Video Products Technical Bulletin 30-2003-093

DATE: **March 24, 2003**SUBJECT: **REUSE IC551 WHEN REPLACING D BOARD**MODEL: ***PVM-2130QM***SERIAL NO: **ALL**

**Figure 1**

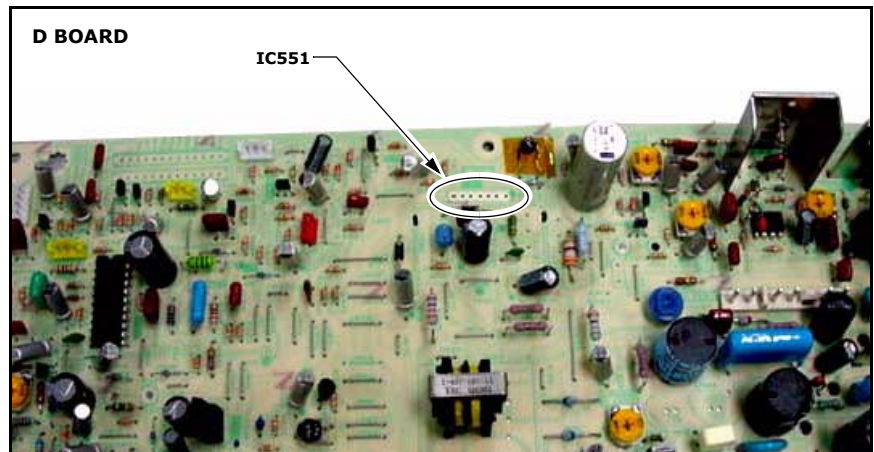
1. Remove IC551 from the former D board. (See Figure 1.)

**Figure 2**

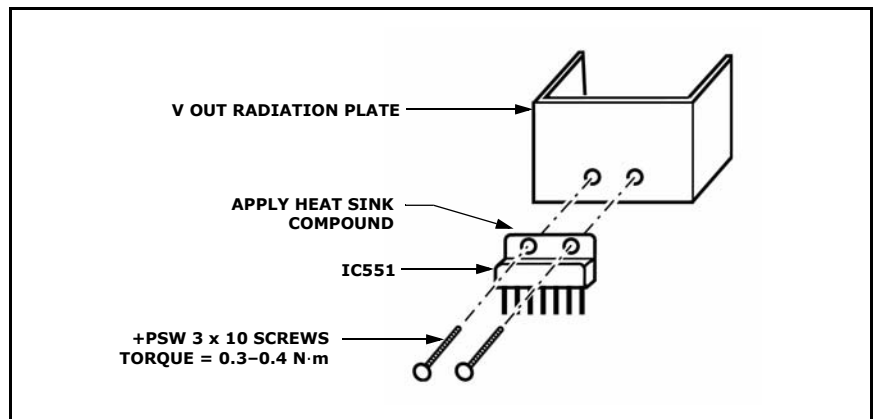
2. Attach IC551 to the V OUT radiation plate using the two +PSW 3 x 10 screws. (See Figure 2.)

NOTE: Do not allow spacing between the radiation plate and IC551 to exceed .5 mm.
